CHANGE ORDER REQUEST NO. 1

RS&H PROJECT No. 213-1882-091
 Mn/DOT S.P. No.:
 FAA AIP No: 3-27-0024-48-10
 PROJECT DESCRIPTION New Passenger Terminal Bid Package 1
WORK SCOPE 2.10 CIVIL & SITE ELECTRICAL

Re: Duluth Int'l Airport, Passenger Terminal Building (Civil Site Work
FAA AIP 3-27-0024-48-10, RS&H Job No 213.1882.091

RFP - 006

BID PACKAGE 1 CONFORMANCE
SHEET NUMBER
C502
(SHEET 2 OF 6)

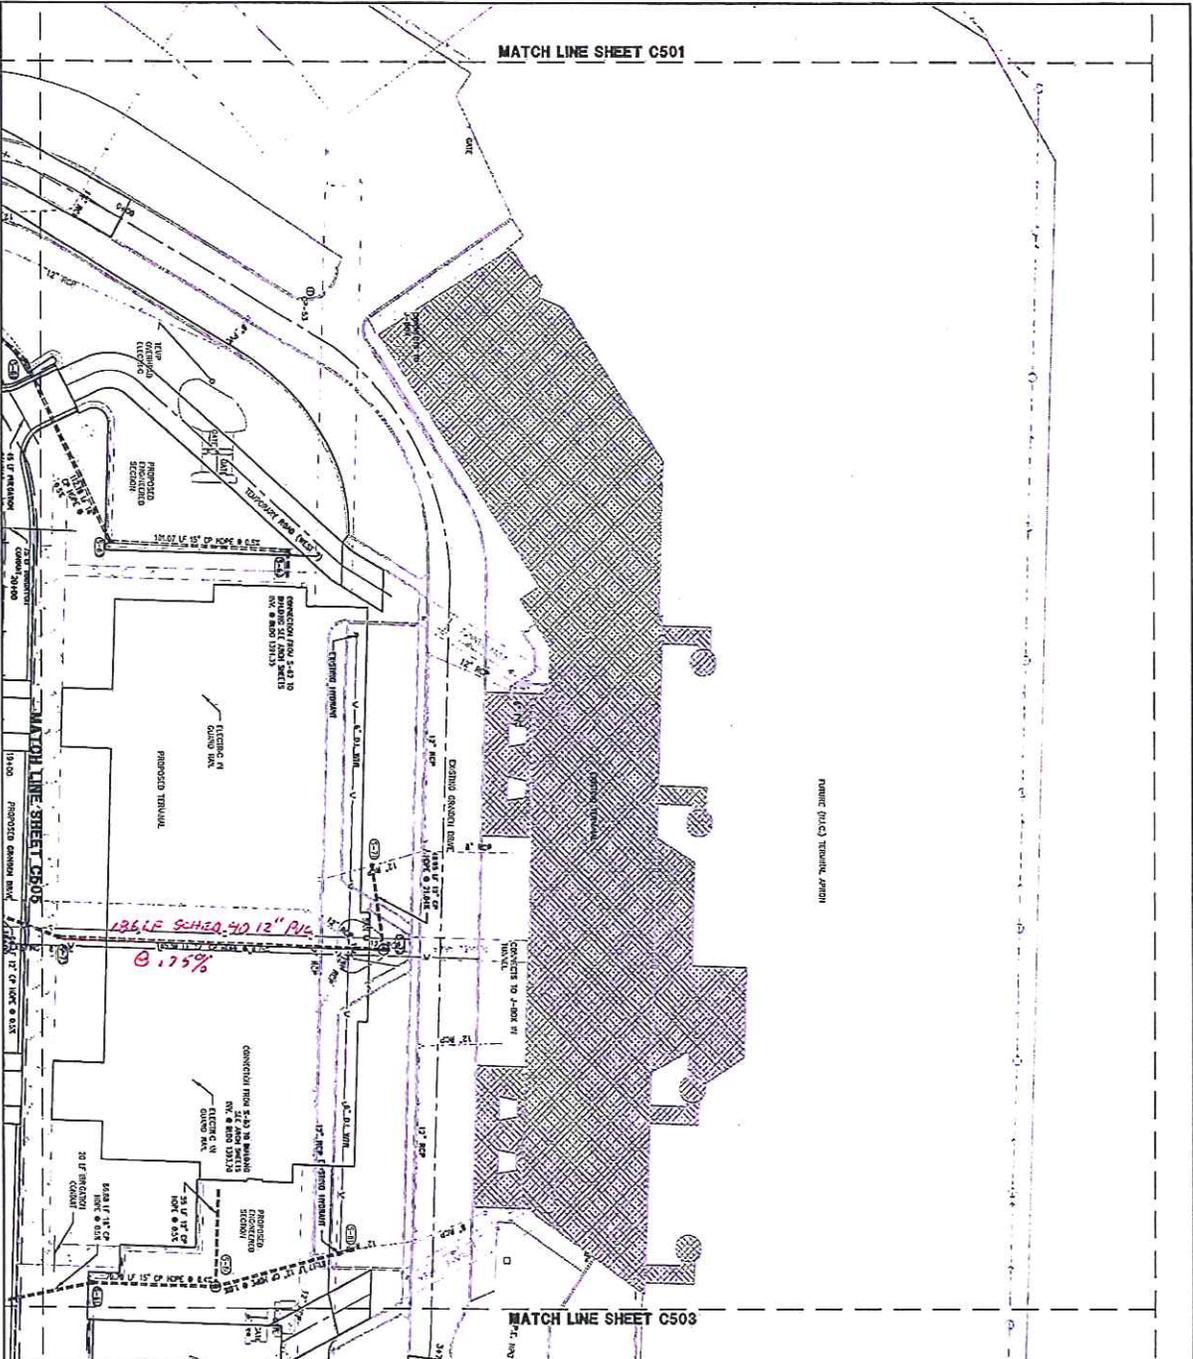
Subject: Temporary storm 12" HDPE under bldg. to be replaced with 12" schedule 40 PVC

Due to permit requirements the Temporary 12" HDPE storm drain that passes under Proposed Terminal between manholes (S-72) and (S-73) will be replaced with 12" Schedule 40 PVC pipe for a total of 186 LF between Manholes.
